DEPARTMENT OF TRANSPORTATION**Federal Highway Administration****23 CFR Part 655**

National Standards for Traffic Control Devices; Revision of the Manual on Uniform Traffic Control Devices**AGENCY:** Federal Highway Administration (FHWA), DOT.**ACTION:** Final Amendments to the Manual on Uniform Traffic Control Devices (MUTCD).

SUMMARY: This document contains amendments to the MUTCD which have been adopted by the FHWA for inclusion therein. The MUTCD is incorporated by reference in 23 CFR Part 655, Subpart F and recognized as the national standard for traffic control devices on all public roads. The amendments affect various parts of the MUTCD and are intended to expedite traffic, improve safety and provide a more uniform application of highway signs, signals, and markings.

R10-3b
225 mm x 300 mm
(9" x 12")

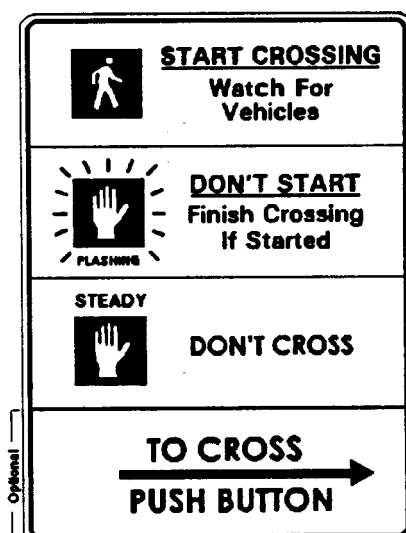
Request IV-124(C)—Educational Plaque for Pedestrian Signals

This amendment will allow the use of an educational plaque that can be used in conjunction with pedestrian signal indications. The FHWA is adopting the use of this optional educational plaque where both symbol-type and word message pedestrian signal indications are used.

A total of 27 of the 30 comments received agreed with the use of the educational plaque. The wording of the plaque shown in the notice of proposed rulemaking has been slightly modified to reflect the following comments:

1. After the wording DONT START use FINISH CROSSING IF STARTED.

2. Pedestrians should be aware of all vehicles, not just turning cars.

3. The highlighted flashing hand symbol is more easily understood.

4. All intersections do not have marked crosswalks.

5. Eliminate the wording WAIT ON CURB because all intersections do not have curbs.

6. Many intersections in the United States do not have push buttons for operating signals and, therefore, the bottom section of the sign with the caption "TO CROSS. . . PUSH BUTTON" should be made optional.

7. Since both symbols and word messages are allowed for pedestrian signal indications, two plaque designs are necessary.

Note: Word message (R10-3c) may be used in place of WALK/DON'T WALK symbol.
